Planning Application Reference Number: VA04.324632

Applicant: Perigus Energy Ireland Midco Ltd.

Proposed development of a 220kV Air Insulated Substation (AIS) and Loop-in Grid Connection at Greenhills Solar Farm. Located in the townlands of Ballyneague, Ballydaniel, Knocknagappagh, County Cork.

Submission to Cork County Council on file reference 26/2133

Figure 1: Proposed Substation Location, Public Roads and Site Notices

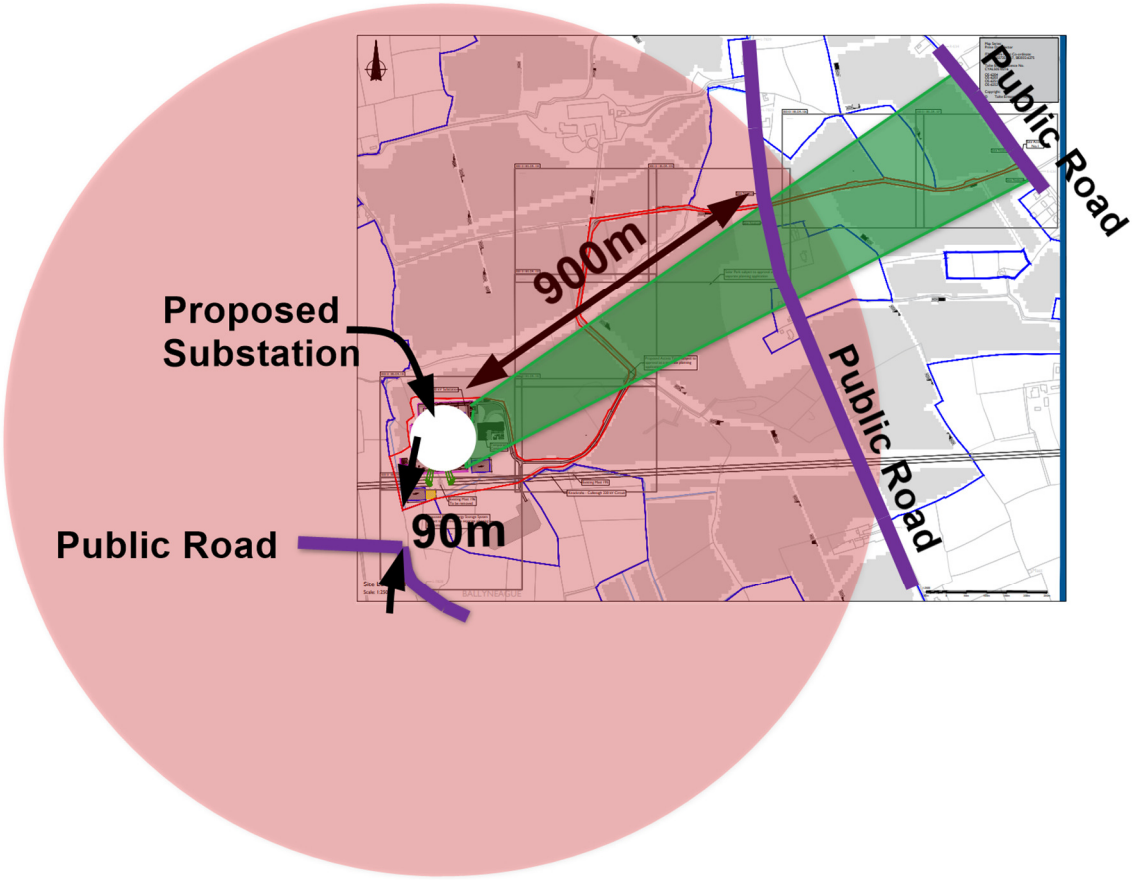
Four site notices have been provided all in a narrow field of view to the northwest of the proposed substation. The closest of these site notices is approximately **900m** from the proposed substation compound.

Figure 2: Map showing walking route to Site Notice from the closest Public Road to the proposed Substation

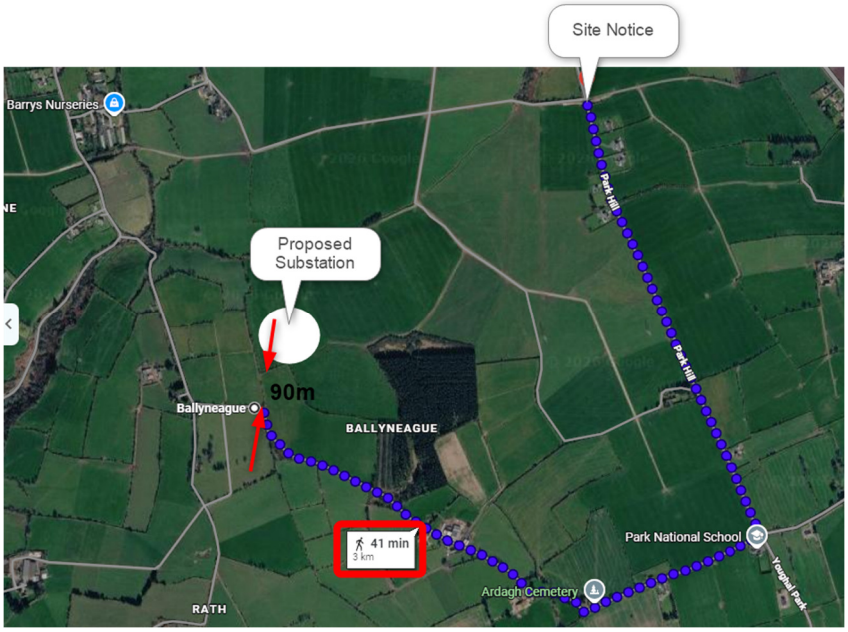
There is a public road approx. **90m** from the southwest corner of the site. The applicant has not provided site notices in this area. The application does not adequately inform those who will be closest to the substation of this planning application – the closest site notice is a 40minute walk (via public road) from the area where the substation is proposed. As such I consider the provision of site notices to be insufficient.

Figure 3: Map showing entrance to site from public road where no site notice is provided. Walking route from our property to the closest public notice indicated

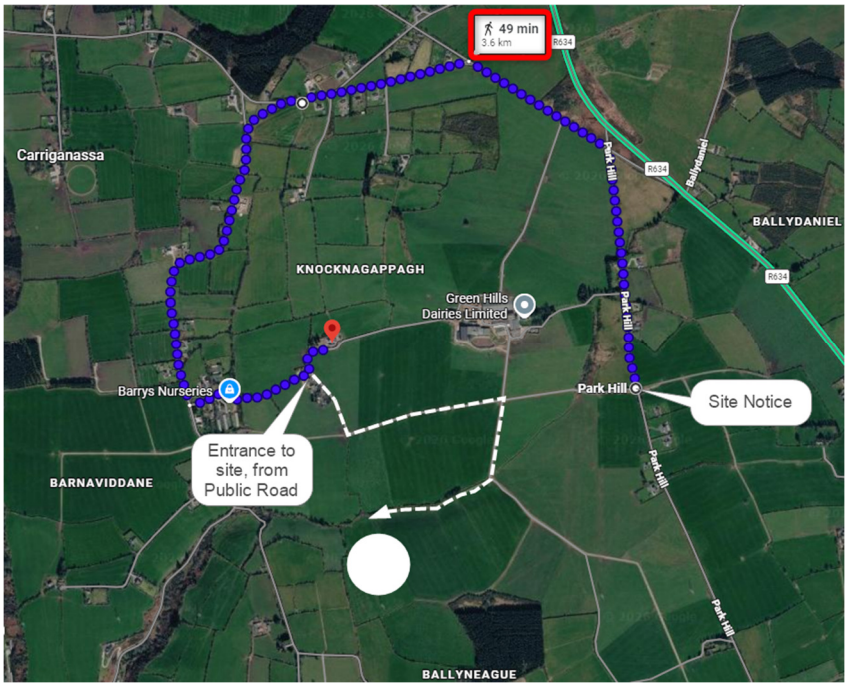
Site notices are not erected at each entrance to the site – as an example, we live at P36W275. There is an existing entrance to the site, from the public road adjacent to our property. The lack of a site notice in this location has hampered our statutory right to comment on this application. The closest site notice is a 49minute walk from our house.

Figure 4: Extract from 300101185-DR-105, highlighting lack of information relating to proposed road crossing point

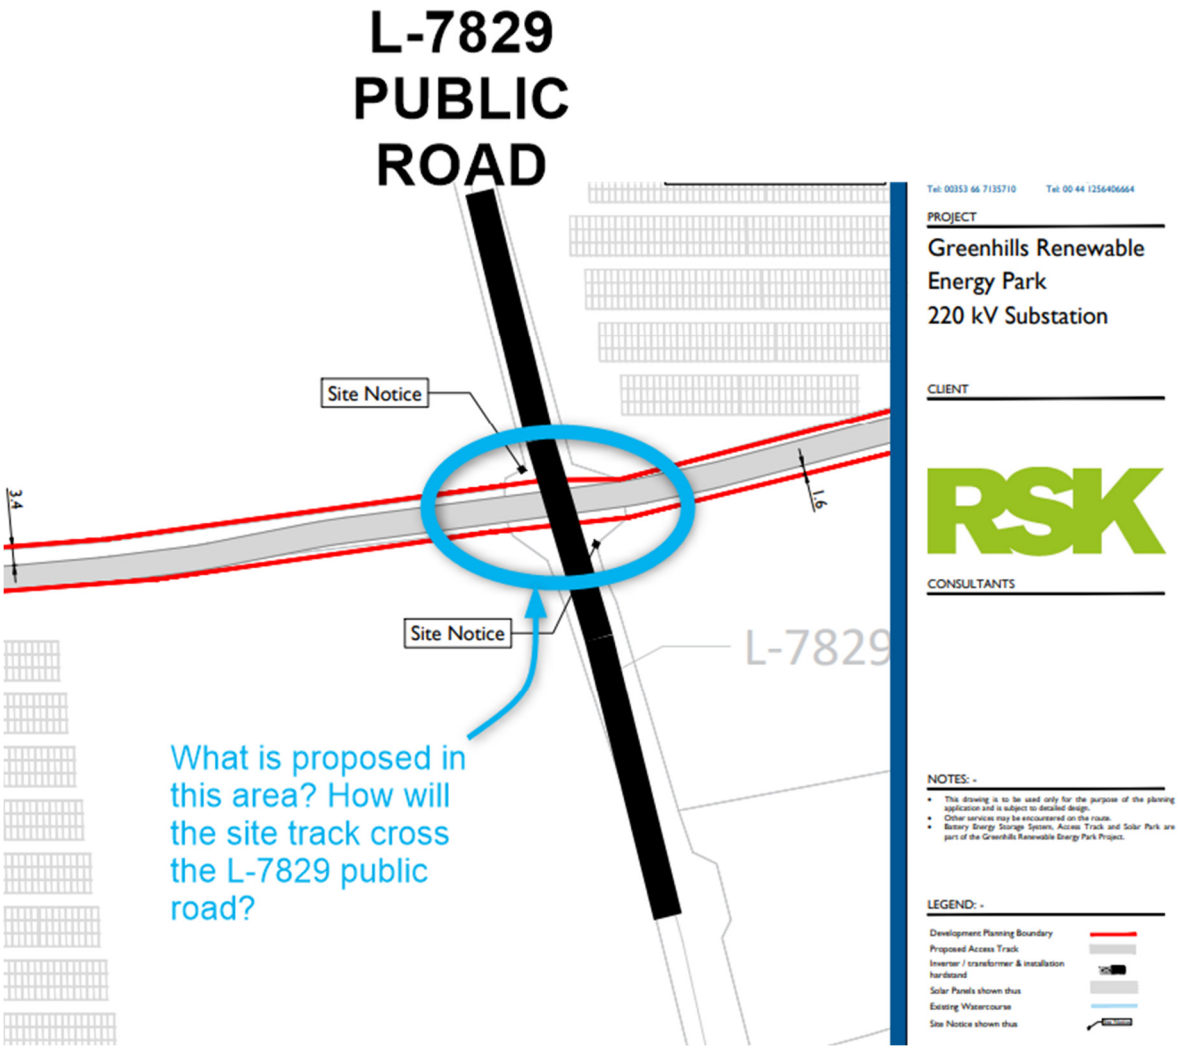
Drawing 300101185-DR-105 provides no clarity in relation to the applicant's proposal for crossing the L-7829. It is unclear how the area will be secured, how sightlines would be achieved, how are these entrances managed, can vehicles pull in off the public road while gates are being opened, how is surface water run off drained etc. The drawing provides no levels or cross sections; how will the crossing be achieved? Will an overpass or underpass be provided? There is an existing agricultural underpass in this area – it is not indicated on the drawing. Information is frustratingly sparce on this drawing.

Figure 6: Aerial Image showing vast open 280 acre open land tract, where Substation proposal is made

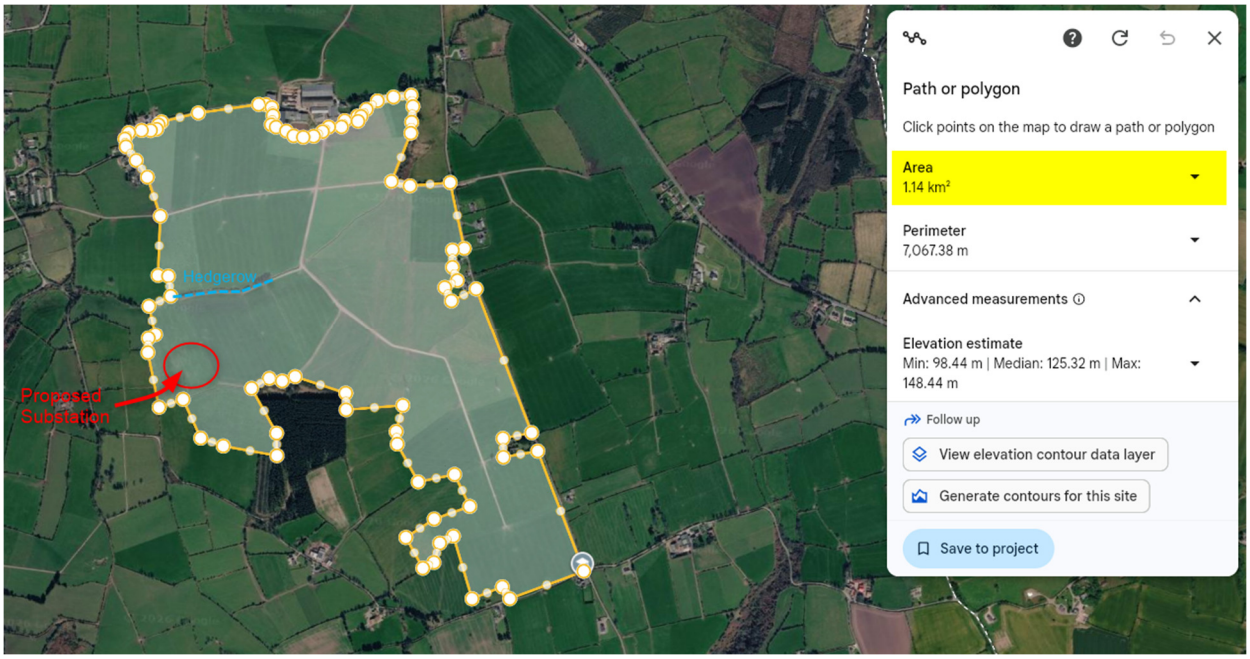
The proposed site sits within a rare, expansive open area of approximately 1.14km² / 280 acres.

The chosen site is fundamentally unsuitable for an industrial substation development of this scale, primarily due to its severe and irreversible impact on the local landscape character.

Introducing an industrial substation into this unbroken landscape will create a visual blight that cannot be effectively mitigated or screened. Airbourne acoustic nuisance will be amplified by the lack of established screening.

Figure 2: Lands at Knocknagappagh, where no site notice has been provided at entrances from public road L38032.

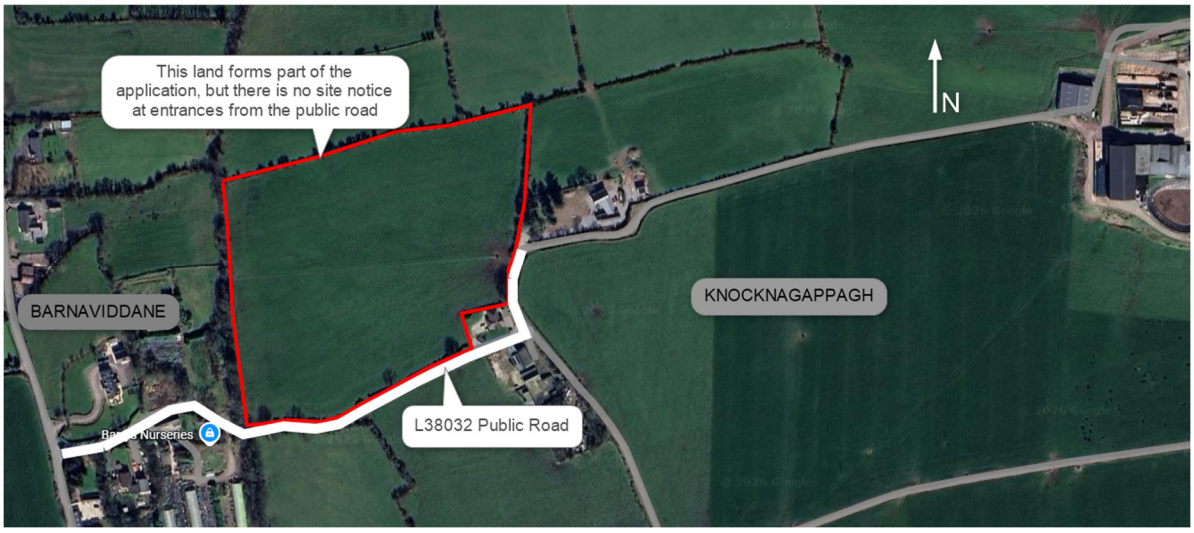
There are locations where parcels of land included in the application drawings do not have any site notices erected. This is unfair and misleading to the public. See below example in Knocknagappagh:

Figure 3: Proposed works outside red line boundary (circled in blue) indicated on extract from 7353- PL-DR-106

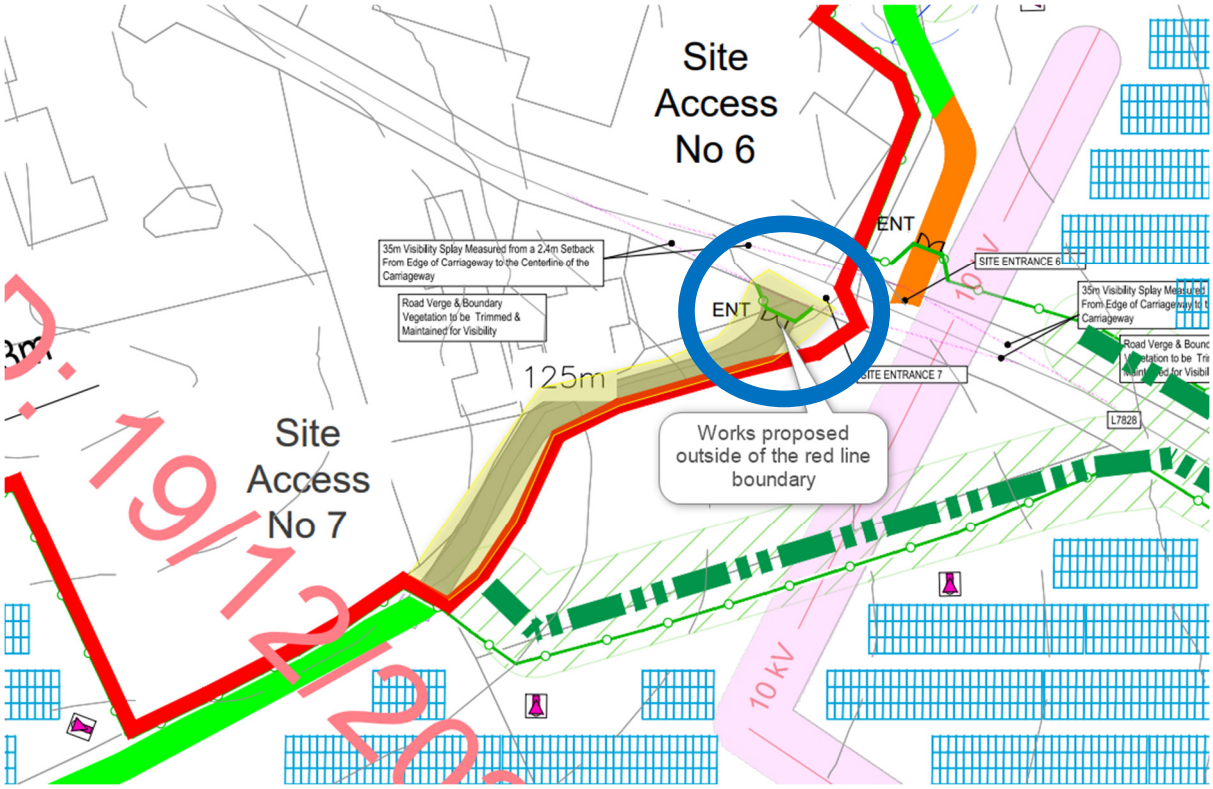
See below extract from drawing 7353- PL-DR-106, which shows a proposed entrance outside of the red line boundary for this application.

Figure 5: Extract from drawing LD.GRNHLLS 1.1 showing hedgerow type 1

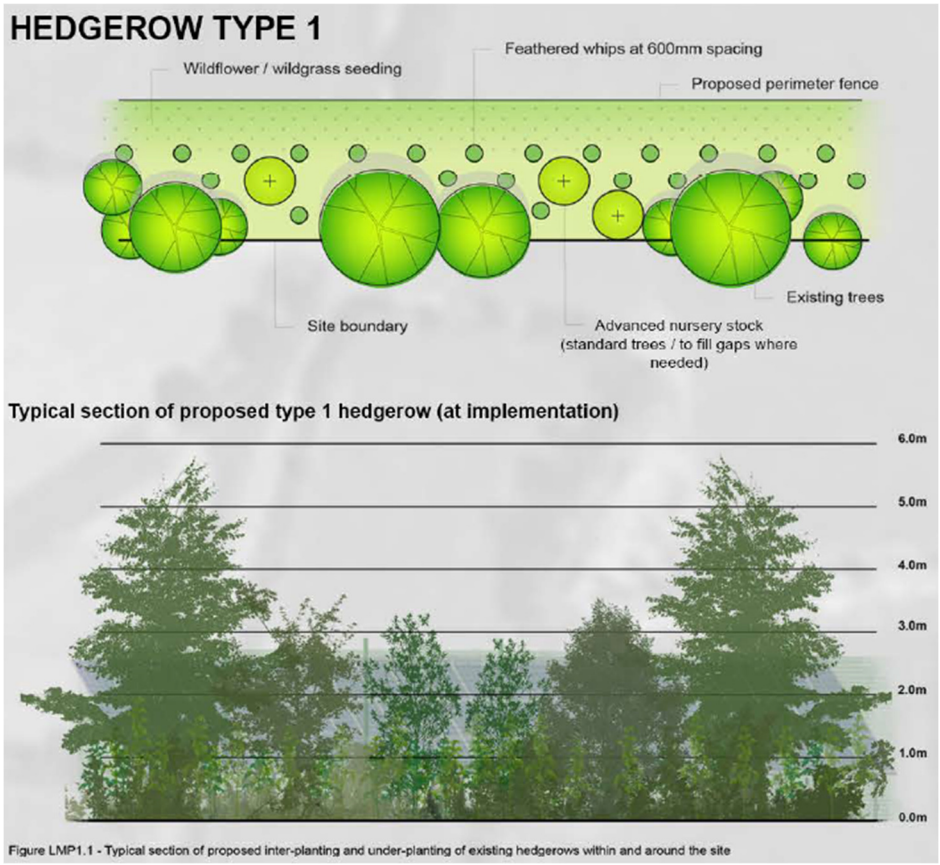
The Landscape Mitigation Plan – Sheet 1 (LD.GRNHLLS 1.1), with the same consultant branding as the Viewpoint VP3a, shows Hedgerow Type 1 in this area. The below elevation (Figure 5) shows this type of hedgerow. It is significantly different from the representation provided in VP3a, showing much of the planting as 3m high, and raises concerns about the accuracy of all viewpoints images provided. The taller vegetation is noted as being existing – there is no existing vegetation in this area which exceeds 3meters in height. A 3m high hedge will not adequately screen the proposal as VP3a suggests.

Figure 6: Mark up of Landscape Mitigation Plan - Sheet 1 DWG No LD.GRNHLLS 1.1, highlighting issues/ concerns

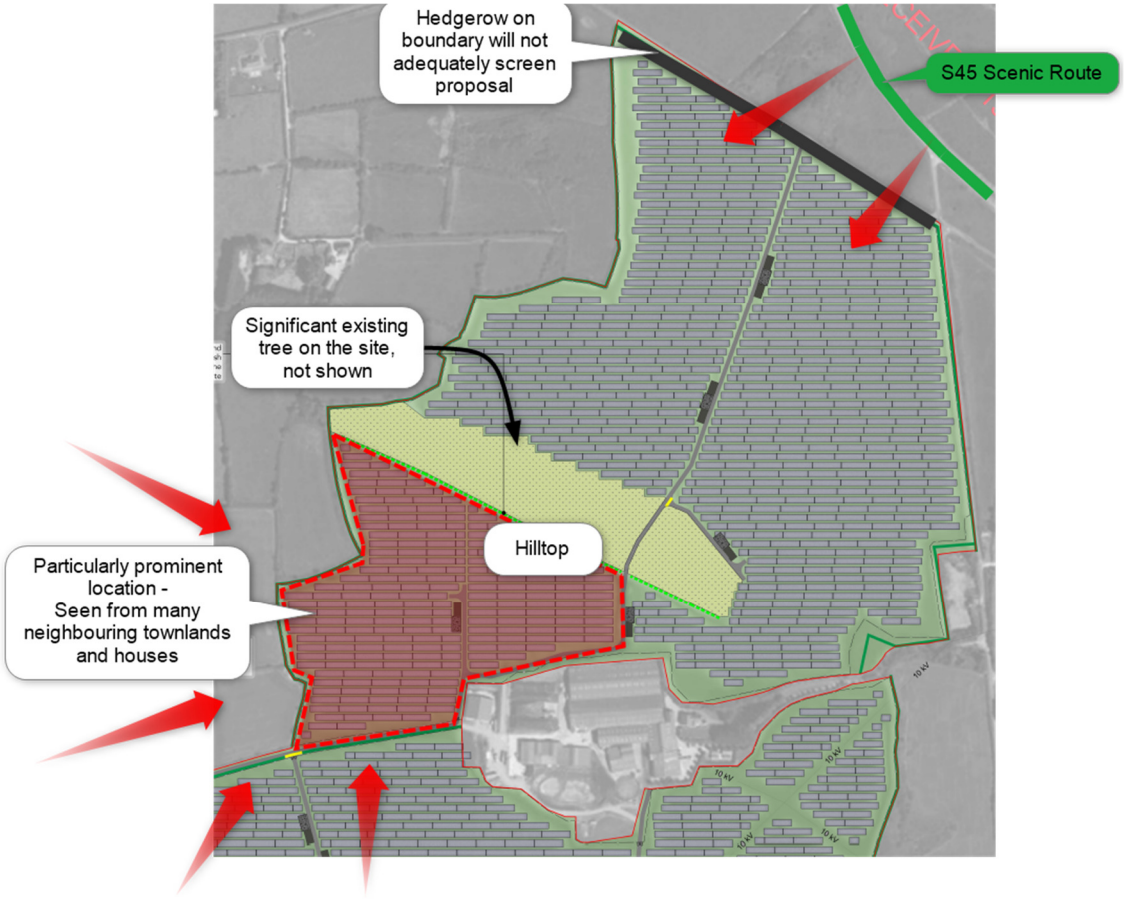
There is a prominent hill within the site, in the townland of Knocknagappagh. It appears that a level of consideration has been given to the impact of the proposal on this hill to the scenic route in the area highlighted in Figure 6.

The south/ west sides of this hill is perhaps more prominent locally, being visible from many neighbouring townlands and houses to the south and west. Solar panels are not appropriate at this part of the site.

It appears that the visual impact of this proposal attempts to be more sympathetic to passing motorists on the Youghal to Tallow Road than residents of the community.

Figure 7: Set back dimensions from residential properties on L7829

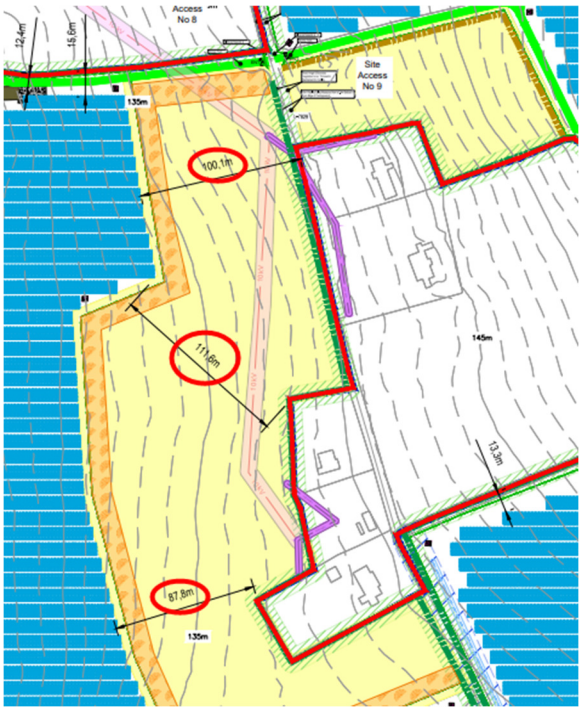
In contrast, planning drawing 7353- PL-DR-109, shows solar panel set back dimensions of 87.8m to 100m from other residential boundaries. The topography of this area is similar to that adjoining our property. It is unclear to us why there is an inconsistent approach to set back design.

For the avoidance of doubt, it should have been proposed that our property would receive the same set back treatment as the properties highlighted on the L7829 road (Circa 100m from the boundary).

Figure 15: Extract from drawing 7353-pl-dr-102 highlighting L3713 Public Road

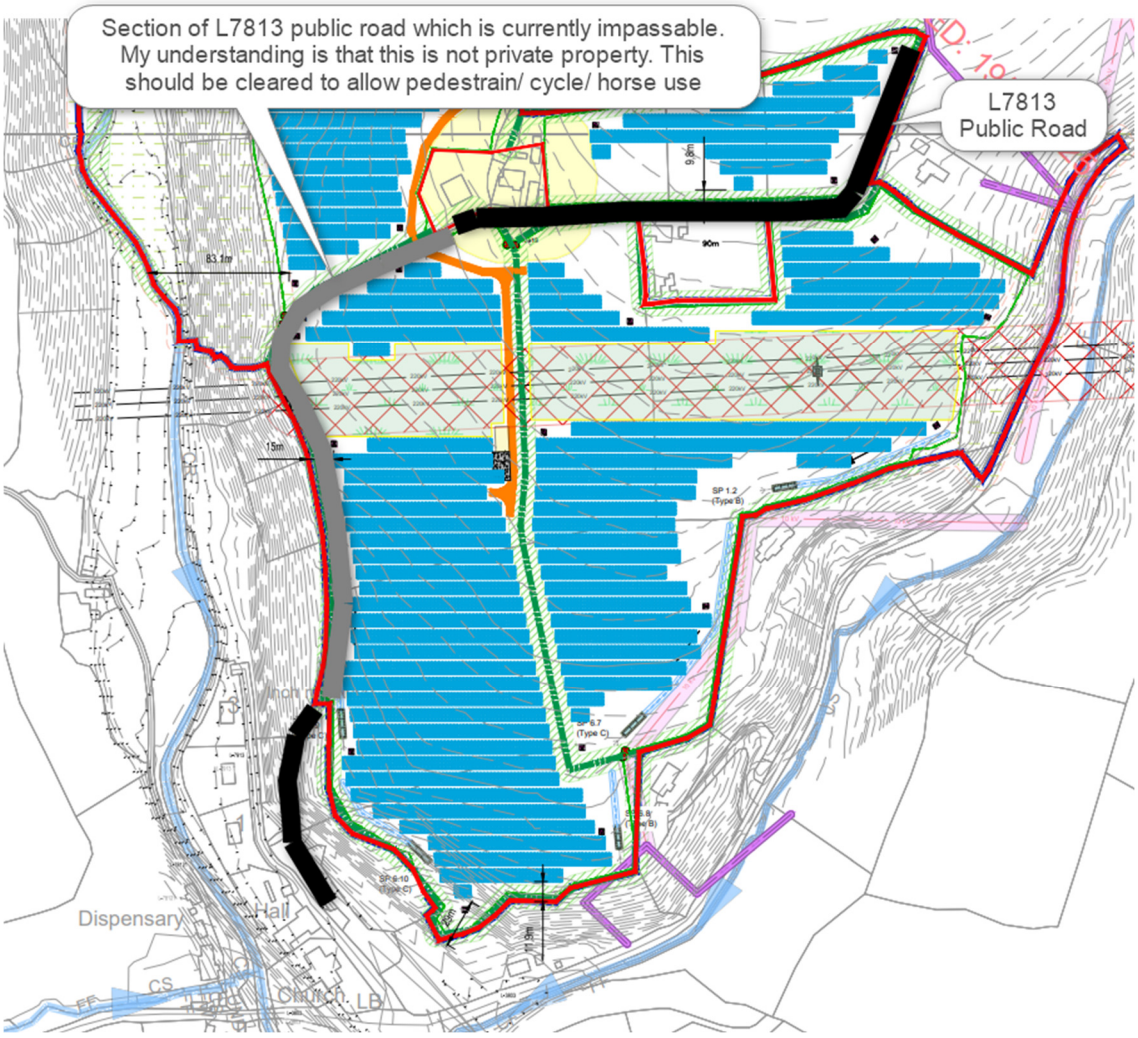
Drawing 7353-PL-DR-102 shows a section of a public road being fenced off, see Figure 15 & 16 below. Cork County Council should ensure that this area is not fenced off. A more proactive approach from the applicant would restore this area as a public passageway, not fence it off.

I ask Cork County Council to take proactive steps to ensure this route is passable for the benefit of pedestrians, cyclists and equestrian pursuits.
